CITY OF ALBUQUERQUE

Re: Weems Law Office - 108 Wellesley Dr., SE
30-Day Temporary Certificate of Occupancy- Transportation Development
Architect's Stamp dated 1-25-16 (K16-D085)
Certification dated 10-25-16

HANDICAP PARKING SIGNS

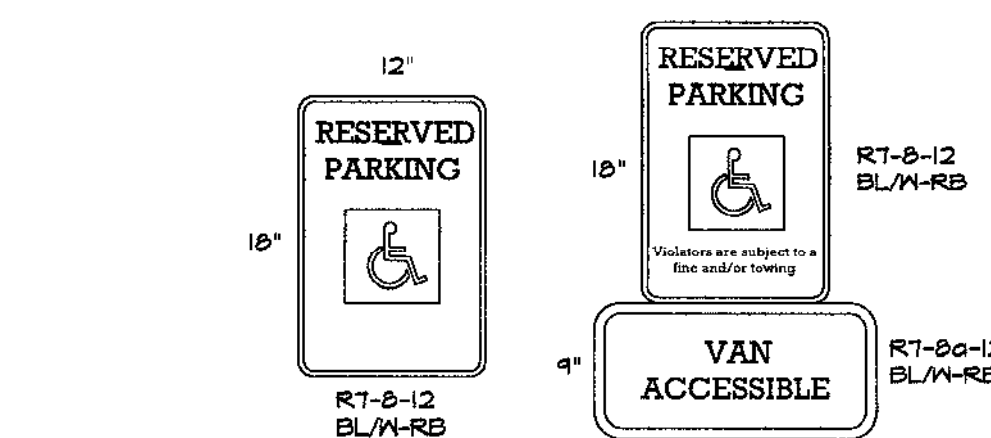
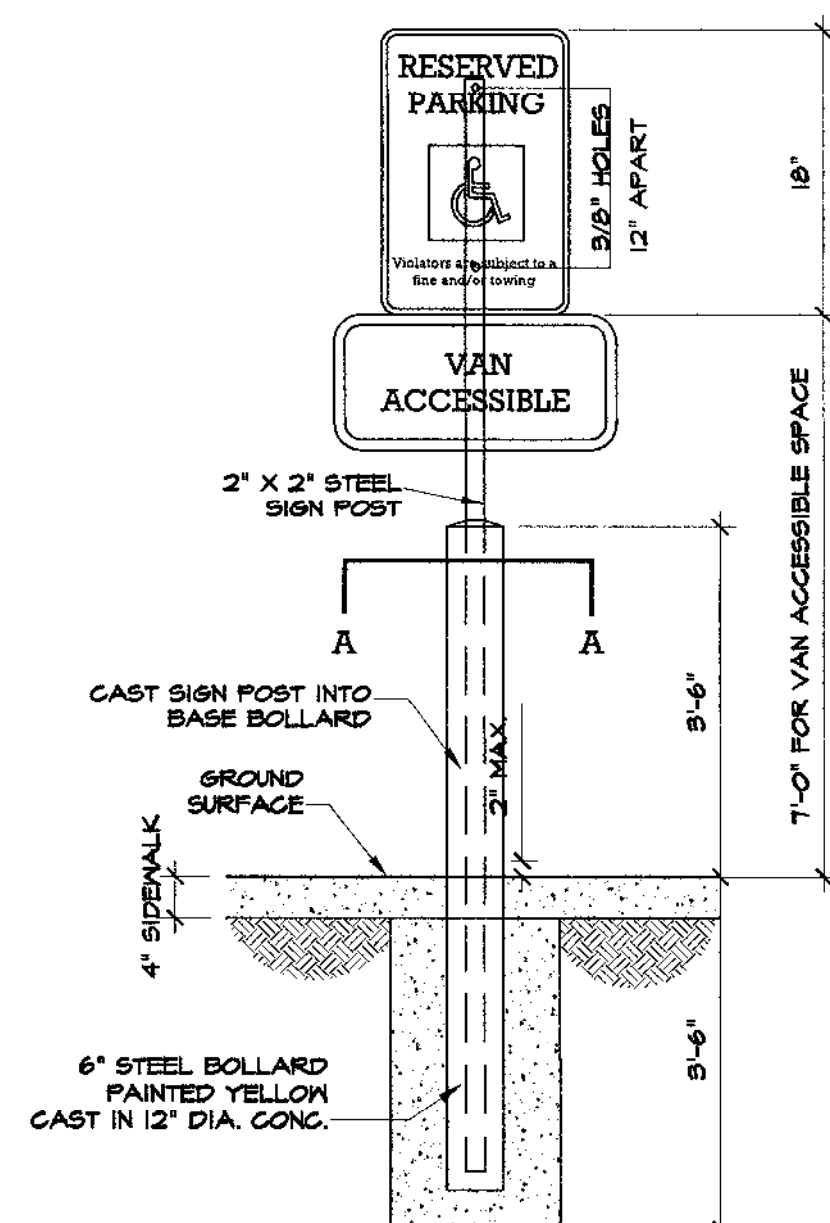
1. The ADA Van accessible parking sign is missing and must have the required language per 66-7-352.4C NMSA 1978 **"Violators Are Subject to a Fine and/or Towing."** Please call out detail and location of HC signs.
2. The ADA access aisles shall have the words **"NO PARKING"** in capital letters, each of which shall be at least one foot high and at least two inches wide, placed at the rear of the parking space so as to be close to where an adjacent vehicle's rear tire would be placed. (66-1-4.1.B NMSA 1978)
3. The ADA parking space must have a clearly visible, blue International Symbol of Accessibility painted on the pavement at the rear of the space (66-1-4.1.E NMSA 1978) or MUTCD recommends a white symbol on a blue background.
